Project: San Angelo ISD Paging Upgrade (RFP #26-008)

Subject: Addendum 01

TECHNOLOGY ITEMS FOR ADDENDUM 01

FLOOR PLAN - LONE STAR MS

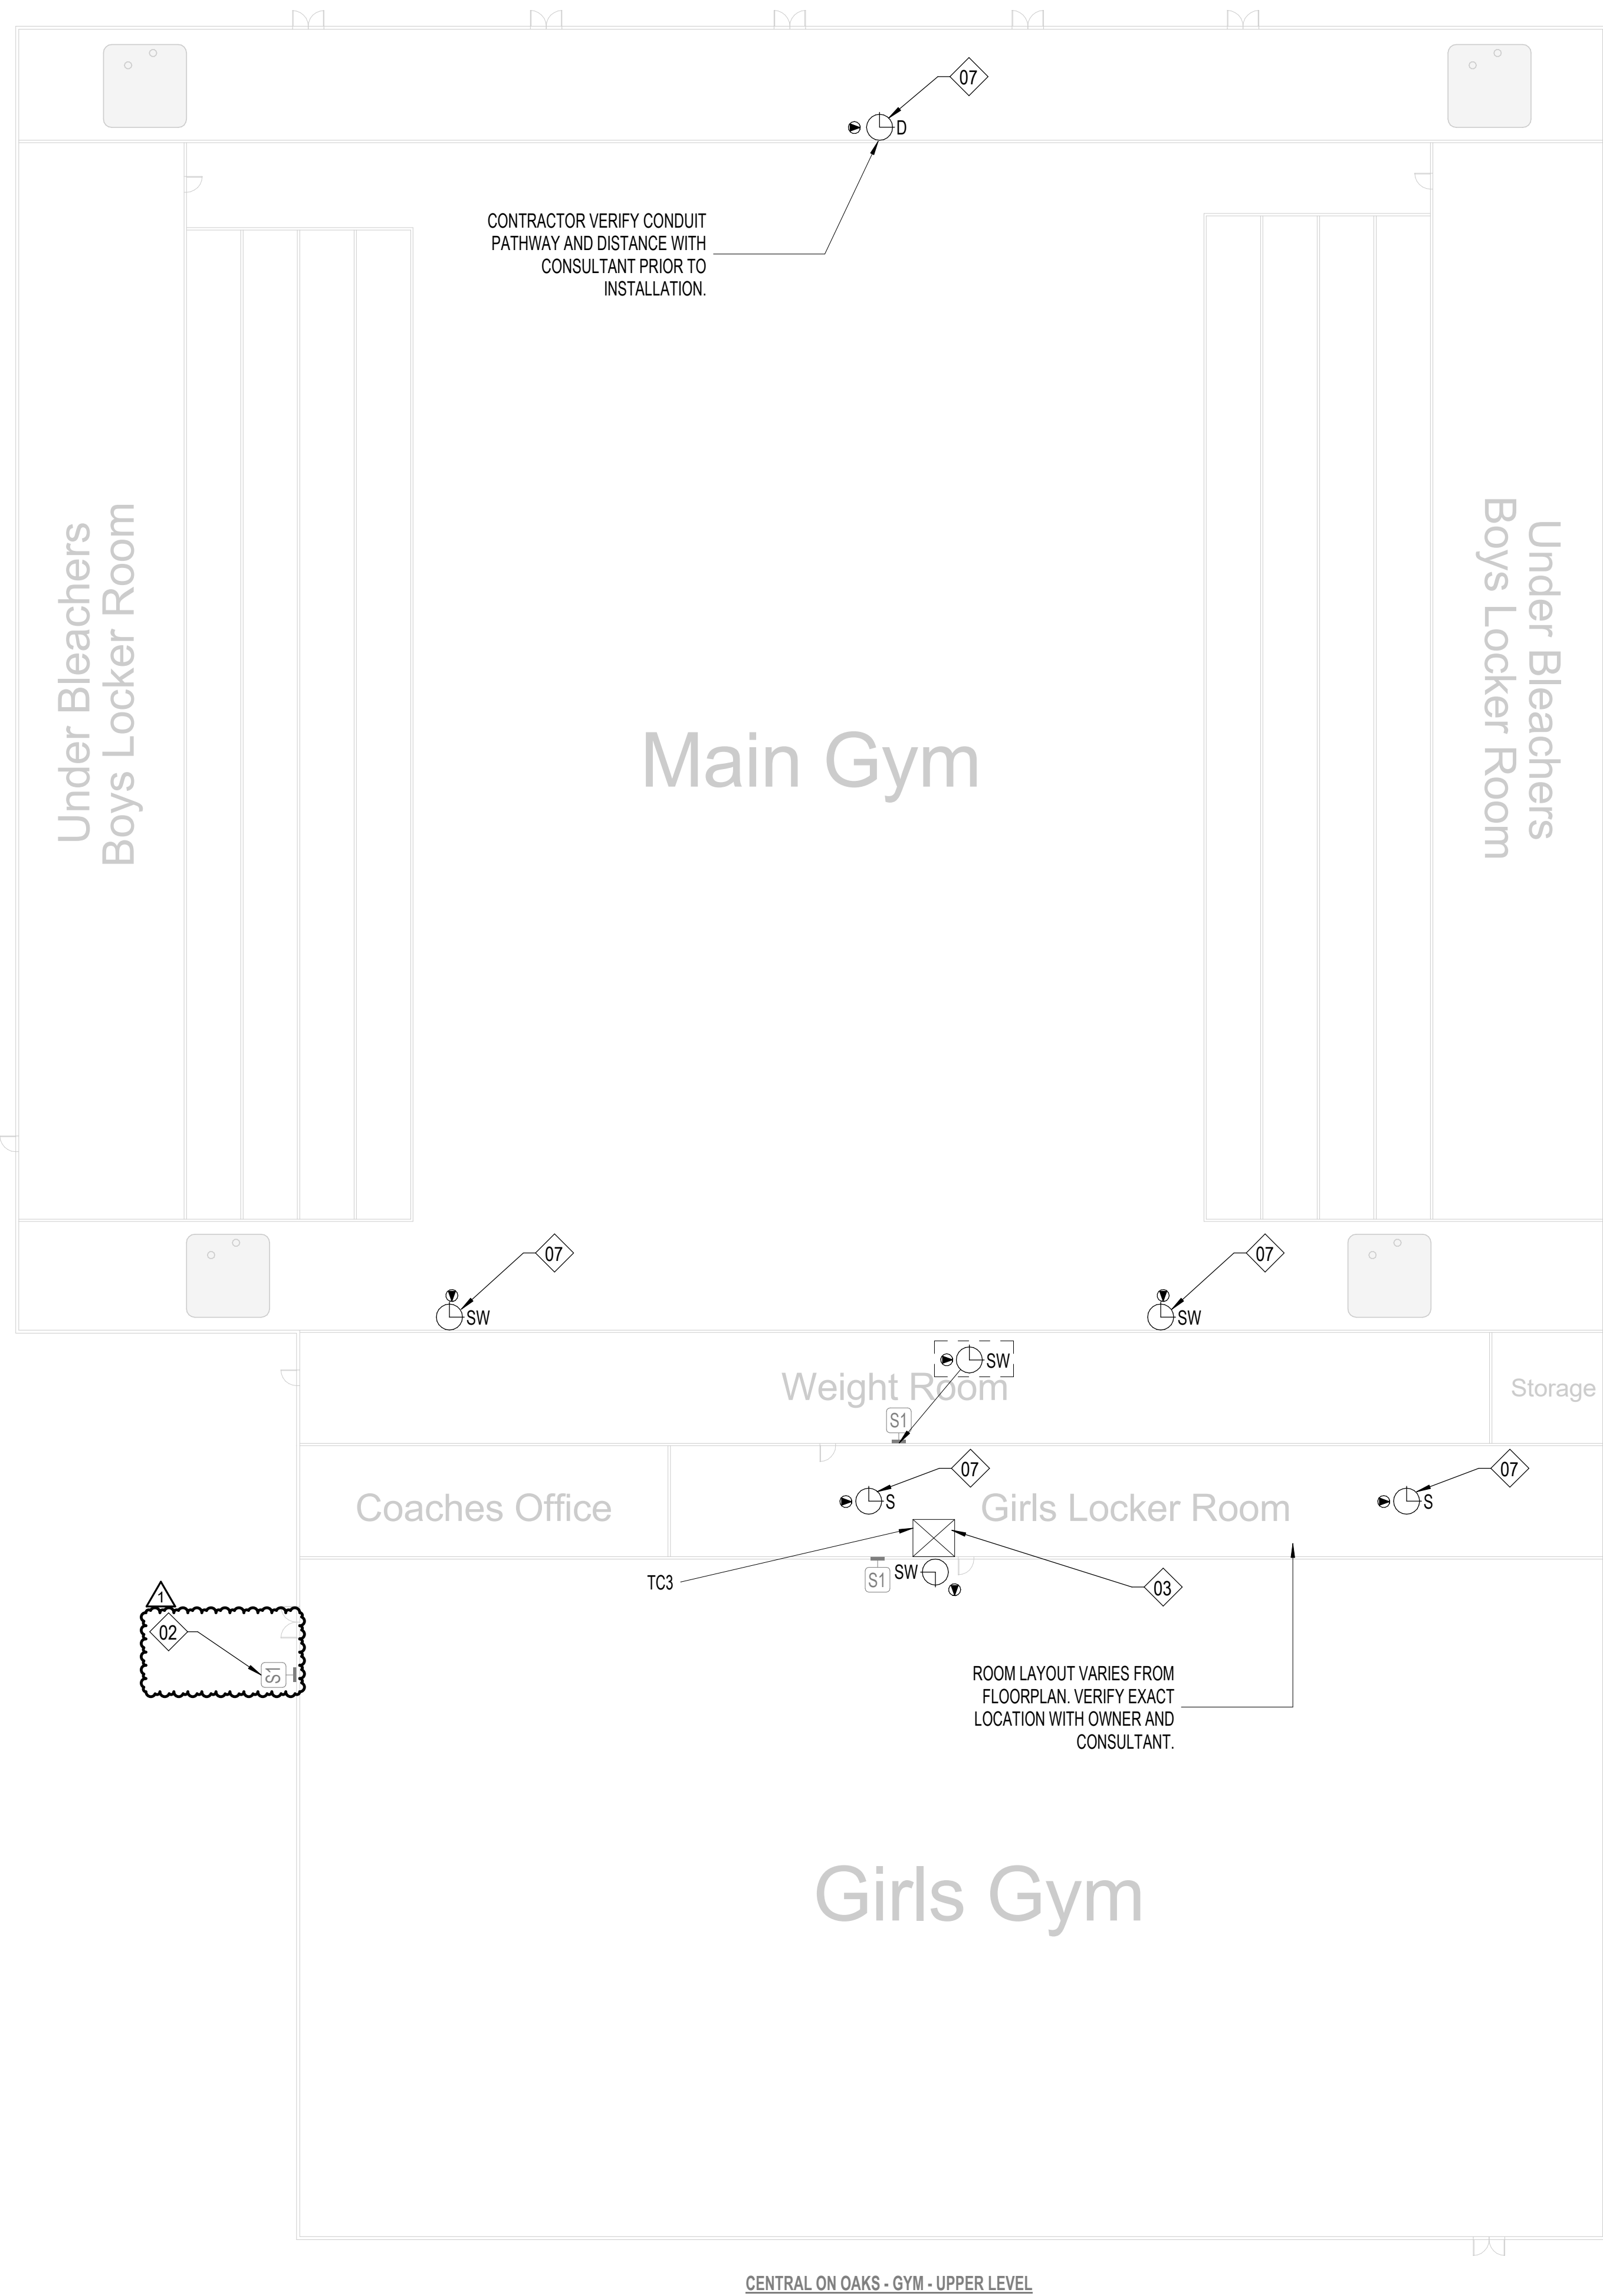
ADD No 1, Tech. Item 35: To the Drawings, Sheet T134, "FLOOR PLAN - LONE STAR ES,"

- 1) Added halftone speaker clarification to Sheet Notes.
- 2) Added paint/finish clarification to Sheet Notes.
- 3) Clarified high-ceiling lift requirement item in Sheet Notes.
- 4) Modified/consolidated Keynote 16/17.
- 5) Removed address from view title.

1 CENTRAL ON OAKS GYM
1136 1/16" = 1'-0"

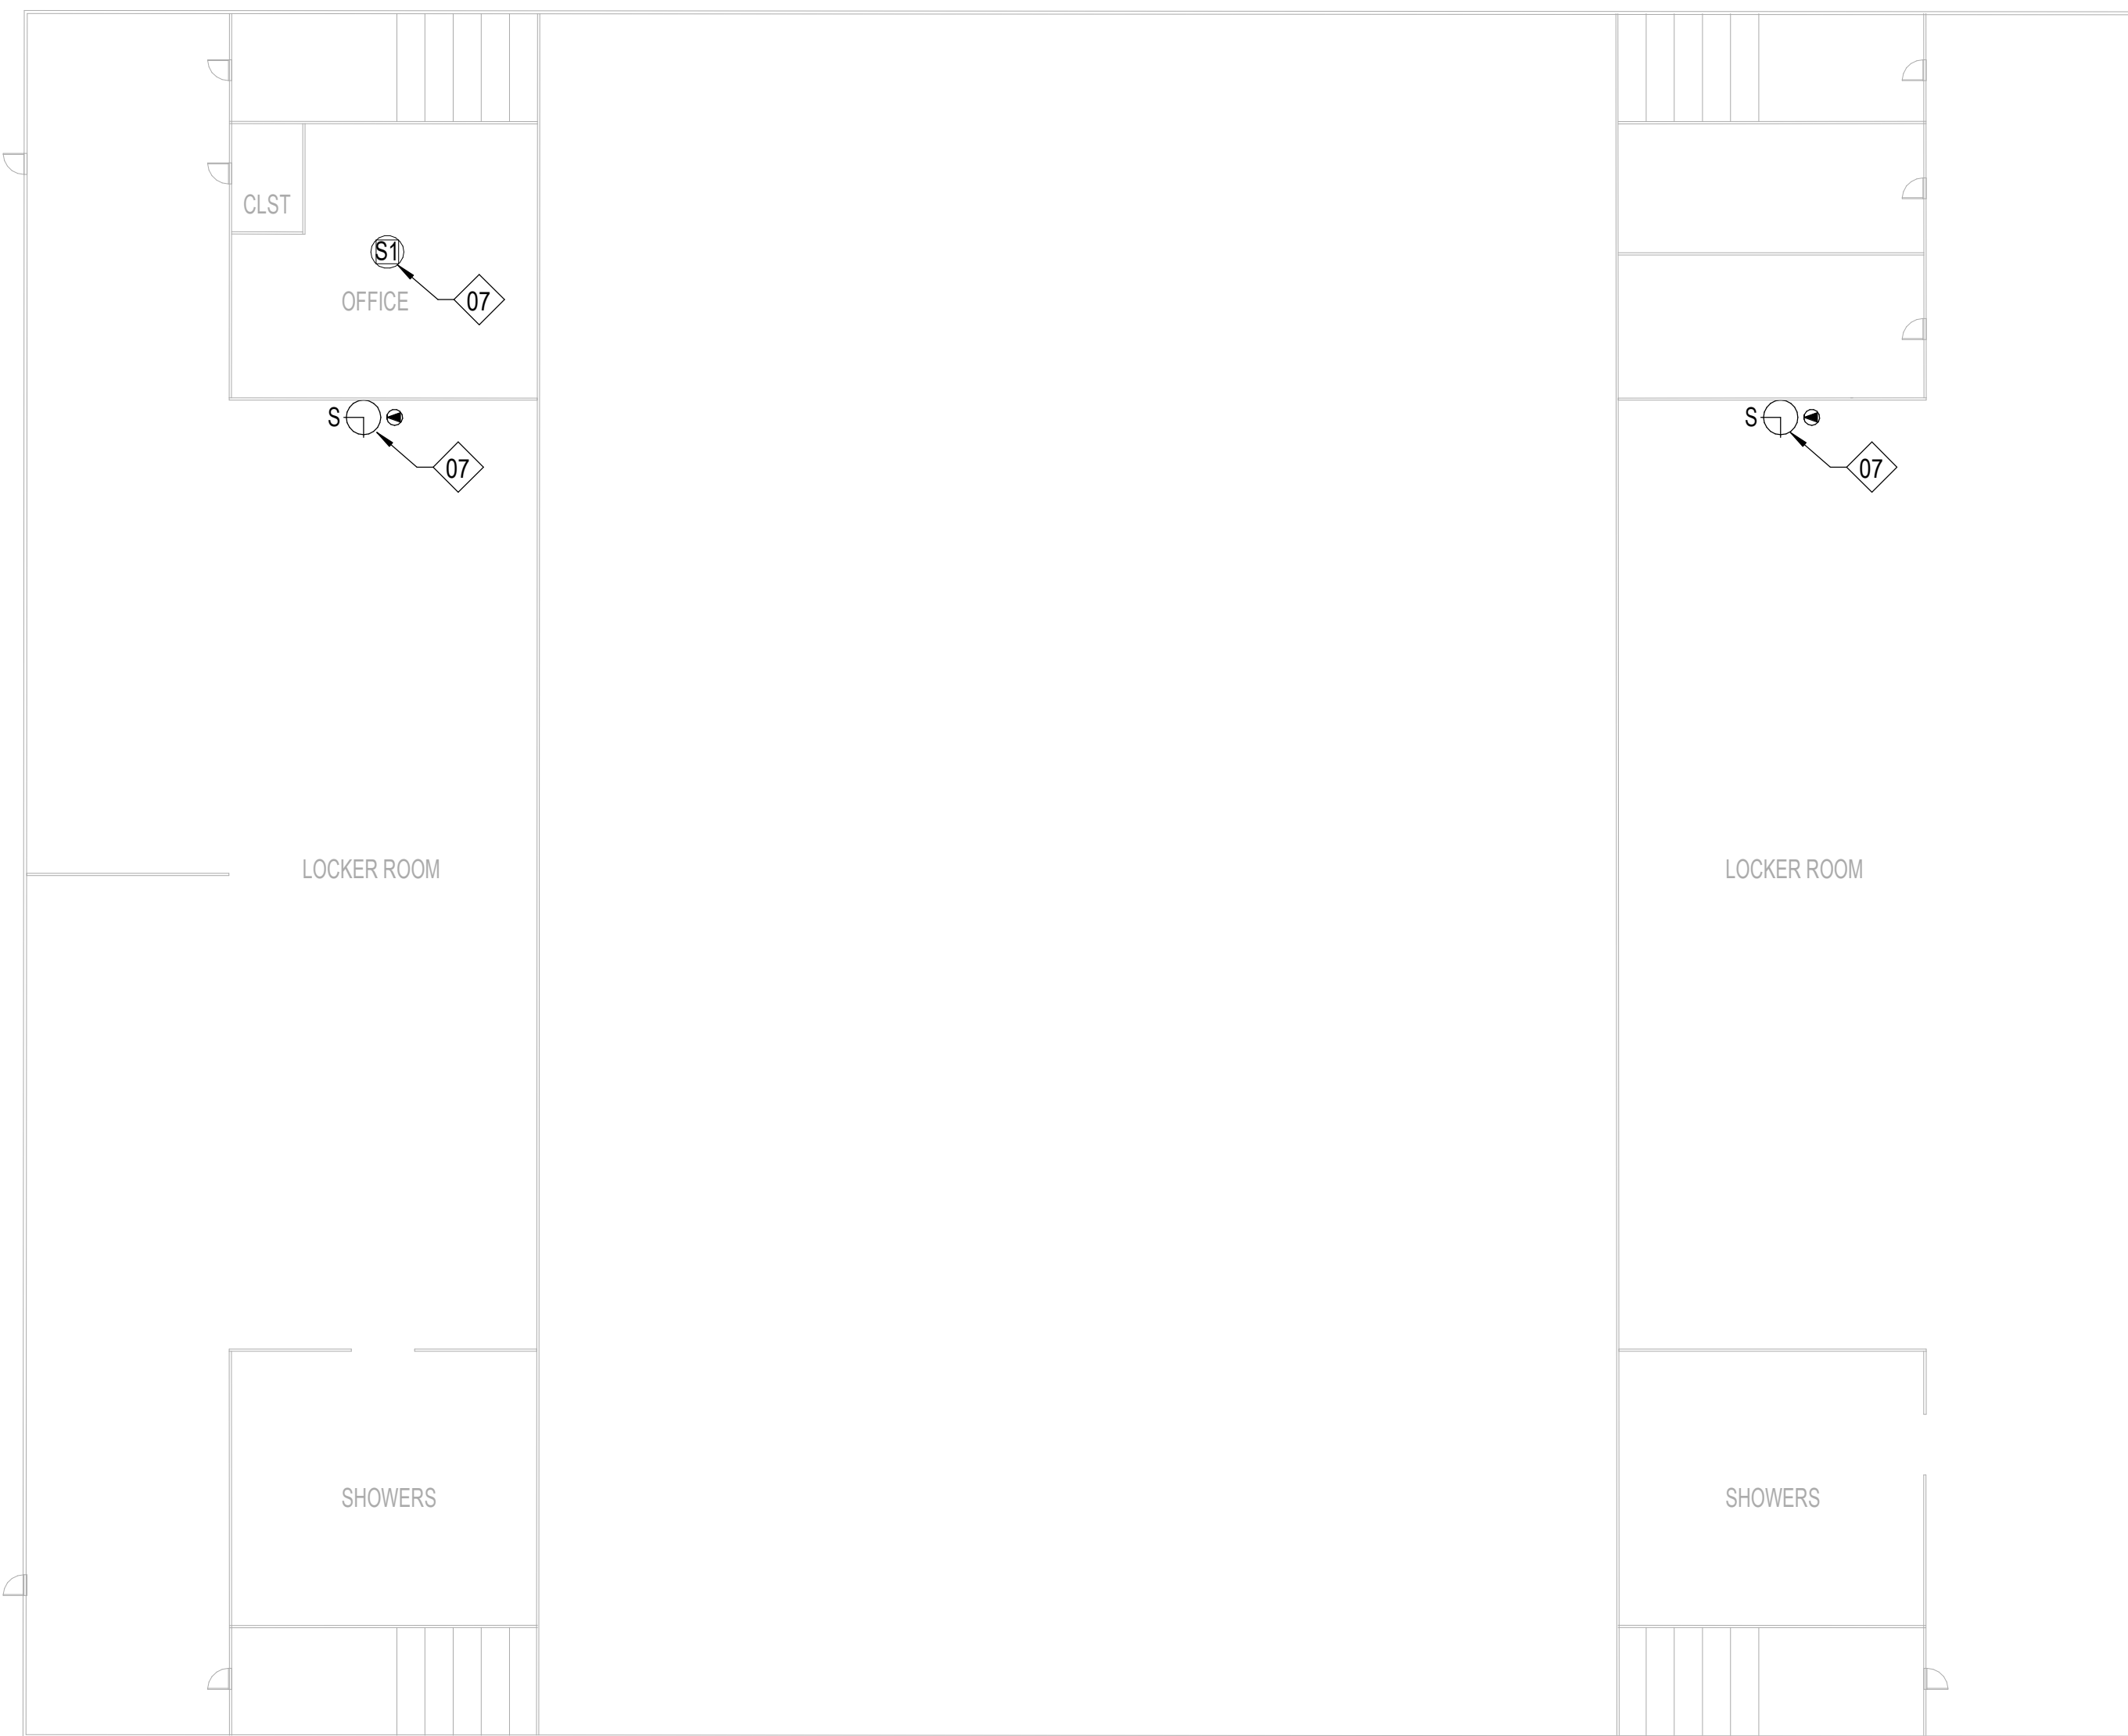
ADD No 1, Tech. Item 37: To the Drawings, Sheet T136, "FLOOR PLAN - CENTRAL ON OAKS (DAEP/PAYS) GYM,"

- 1) Added halftone speaker clarification to Sheet Notes.
- 2) Added paint/finish clarification to Sheet Notes.
- 3) Clarified high-ceiling lift requirement item in Sheet Notes.
- 4) Modified/consolidated Keynote 16/17.
- 5) Added existing exterior S1 paging horn to plan West wall adjacent to Girls Gym with Keynote 02.
